**Enclosure 1**  
**Revision to COLA Section 3H.6**

**RAI 03.07.02-25****QUESTION:****Follow-up Question to RAI 03.07.02-16 (STP-NRC-100036)**

**RAI 03.07.02-26****QUESTION:****Follow-up Question to RAI 03.07.02-17 (STP-NRC-100035)**

**RAI 03.07.02-27****QUESTION:****Follow-up to Question 03.07.02-19 (STP-NRC-100093)**

**Figure 03.07.02-25.1: Node locations for spectra comparison on Original SSI Model  
(North is along Y-Axis)**

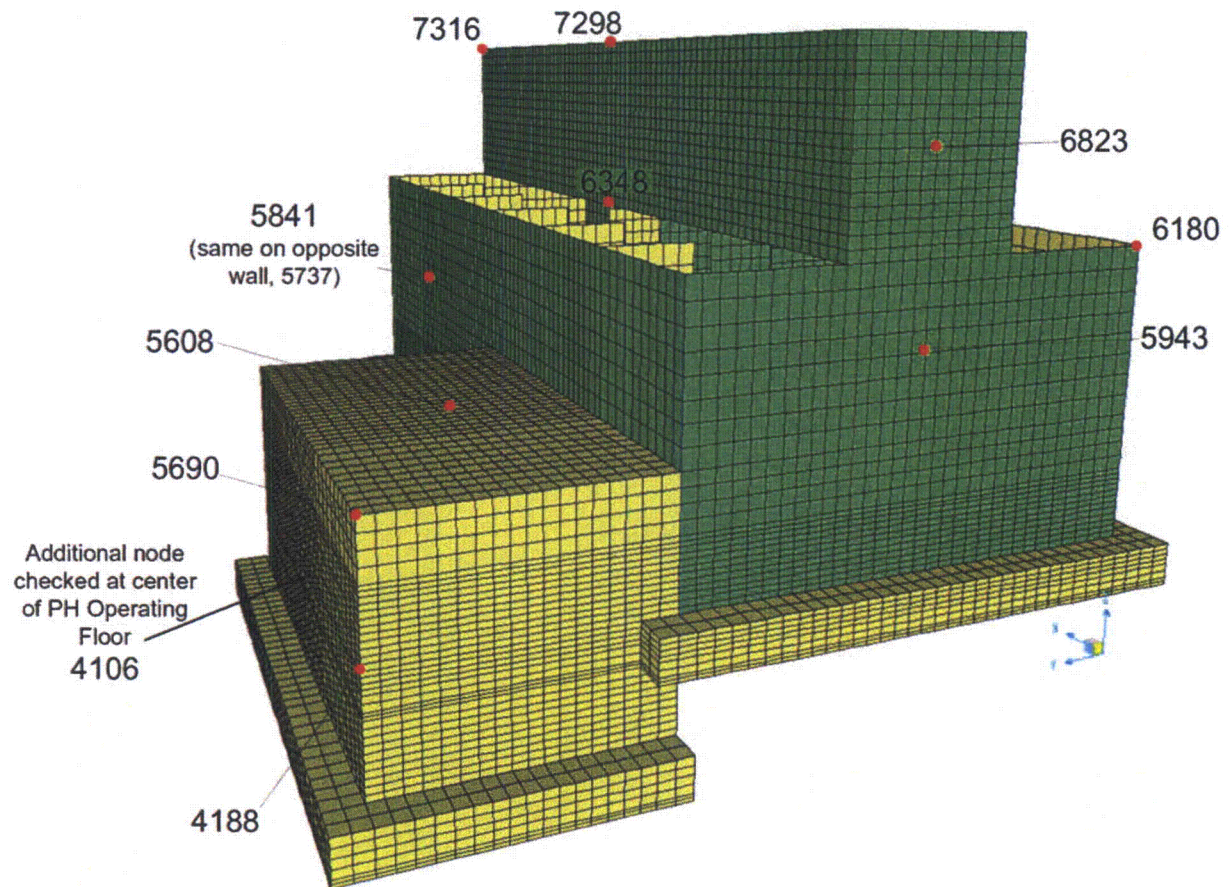
10CFR50, Appendix S requires that evaluation for SSE must take into account soil-structure interaction (SSI) effects. In the response to Item 1 of RAI 03.07.02-16 with regard to the adequacy of the structural mesh size used in the SSI analysis, the applicant has presented comparisons of the first two modes of the fixed-base structure in the E-W direction ( $f_1 = 2.133$  and  $f_2 = 2.056$  Hz) and N-S direction ( $f_1 = 3.187$  and  $f_2 = 3.028$  Hz) calculated using the SSI and design meshes. Although the comparisons of the two modes are good, they only represent a mass participation of about 17.1% and 15.4% for the E-W and N-S directions, respectively. In addition, the local modes are not reflected in these comparisons. As such, the applicant is requested to provide comparisons of the higher modes that include the out-of-plane modes of the slabs and walls to ensure the adequacy of the SSI mesh for transmitting frequencies of at least 33 Hz. This should include comparisons of in-structure response spectra of slabs, roofs and wall panels for the fixed-base structure calculated using the coarse SSI and fine design meshes subject to representative horizontal and vertical foundation motions. The staff needs this information to determine that the coarse mesh size (for modeling the structure) used in the SSI analysis is adequate for evaluation of SSI effect.

- Figures 03.07.02-25.1 thru 03.07.02-25.3 show original SSI model, refined SSI model, and refined structural model, respectively. Figures 03.07.02-25.6 thru 03.07.02-25.8 show Pump House roof to the same scale from the original SSI model, refined SSI model, and refined structural model, respectively.

- The node locations for comparison of in-structure response spectra are shown in Figures 03.07.02-25.1 thru 03.07.02-25.3 for the original SSI model, refined SSI model, and refined structural model, respectively. These locations include the Pump House Operating Floor, Pump House Roof, UHS Basin Walls, and UHS Cooling Tower Walls. The node locations for comparison of maximum accelerations, in addition to those locations for comparison of in-structure response spectra, include those shown in Figures 03.07.02-25.4 and 03.07.02-25.5.

**Figure 3H.3-50: SSI and SSSI Lateral Seismic Soil Pressures (psf) on Radwaste Building East Wall**

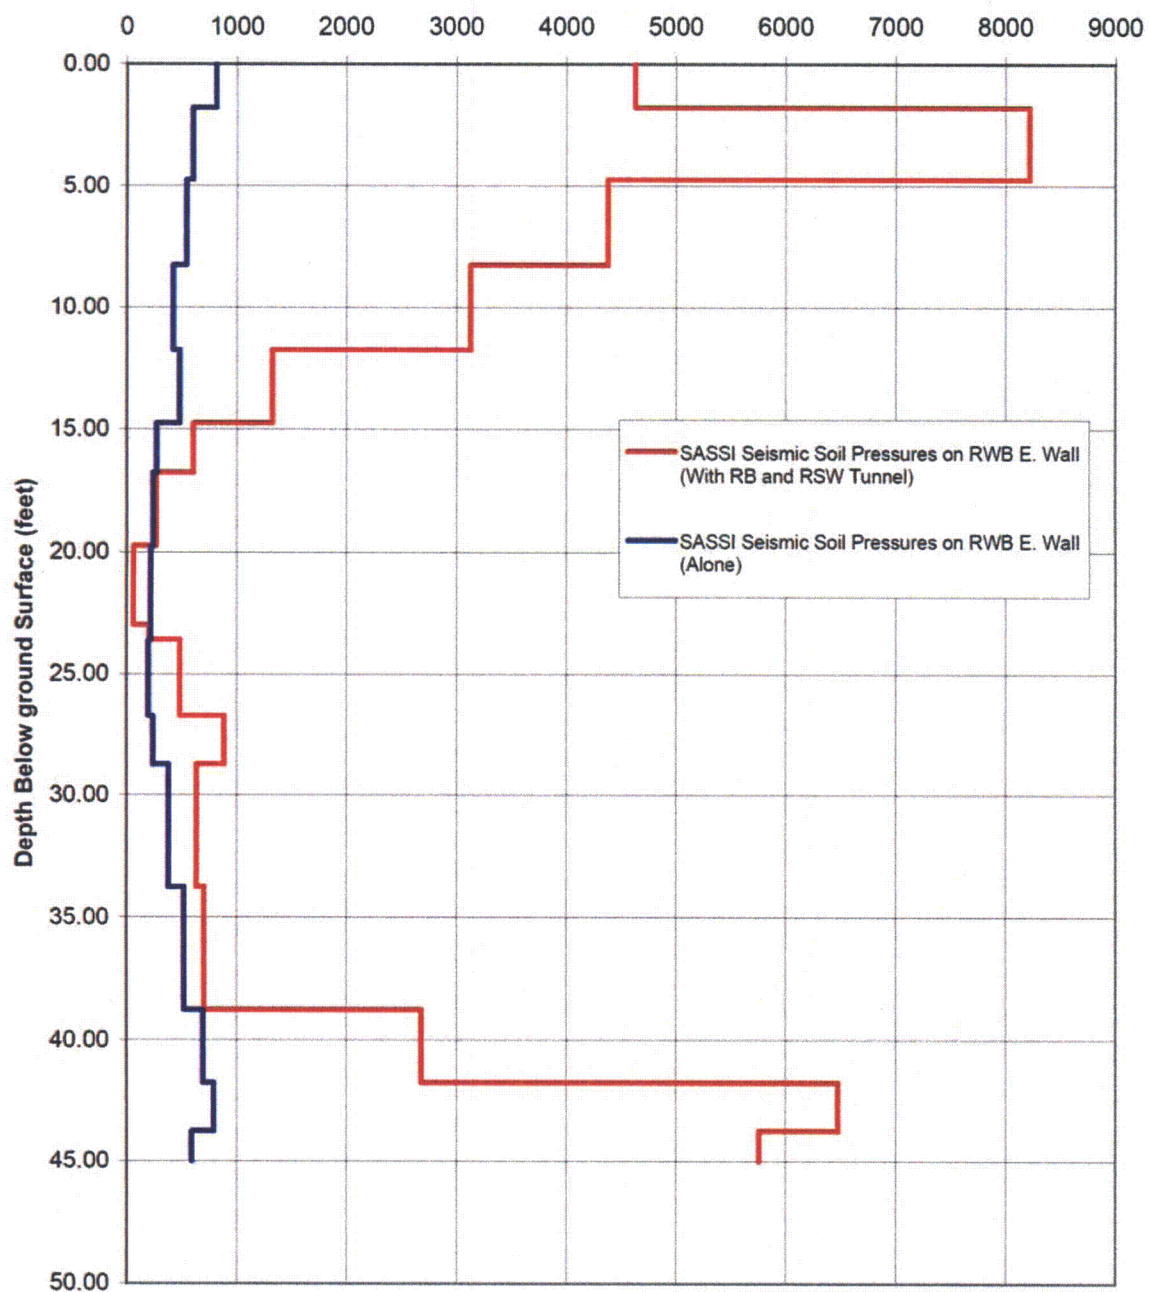
The COLA markup provided in the response to RAI 03.07.02-19, Revision 1 describes the procedure for establishing the SSE input at the foundation level of the RWB. According to this procedure, five interaction nodes at the depth corresponding to the bottom elevation of the RWB foundation will be added to the 3-D SSI model of the Reactor Building (RB). These five nodes correspond to the four corners and the center of the RWB foundation. The RB SSI model is analyzed for the STP site-specific SSE. The envelop of the resulting response spectra at the foundation level of the RWB (based on the average of responses at the 5 nodes) and 0.3g Regulatory Guide 1.60 response spectra will be used as the design response spectra for II/I evaluation of the RWB. This procedure for estimating the foundation input motion for the seismic SSI response analysis of non-Category I structures is acceptable. However, the procedure does not address the potential increase in dynamic soil pressures on the exterior walls of RWB due to the SSSI effects. The applicant is requested to describe how the increase in dynamic soil pressures on the RWB walls due to the SSSI effects will be accounted for in the design of the RWB exterior walls. The staff needs this information to ensure that the RWB exterior walls are adequately designed to maintain its structural integrity during a SSE in controlling any potential release of radioactive materials to the environment.

The resulting seismic soil pressures on the east and west walls of the RWB from the SSSI analysis are shown in Figures 3H.3-50 and 3H.3-51 in Enclosure 1, respectively.

The RWB east and west walls have been evaluated considering the SSSI seismic soil pressures in Figures 3H.3-50 and 3H.3-51. The evaluation confirmed that the existing design as reported in response to RAI 03.08.04-18, Revision 1, (submitted with letter U7-C-STP-NRC-100124 dated June 2, 2010) is adequate.

The RWB east and west walls are also designed for lateral seismic soil pressures shown in Figures 3H.3-50 and 3H.3-51, respectively. These soil pressures consider the structure-soil-structure interaction (SSSI) between the RWB, RSW piping Tunnel, and RB. For details of this SSSI analysis, see Section 3H.6.5.3.
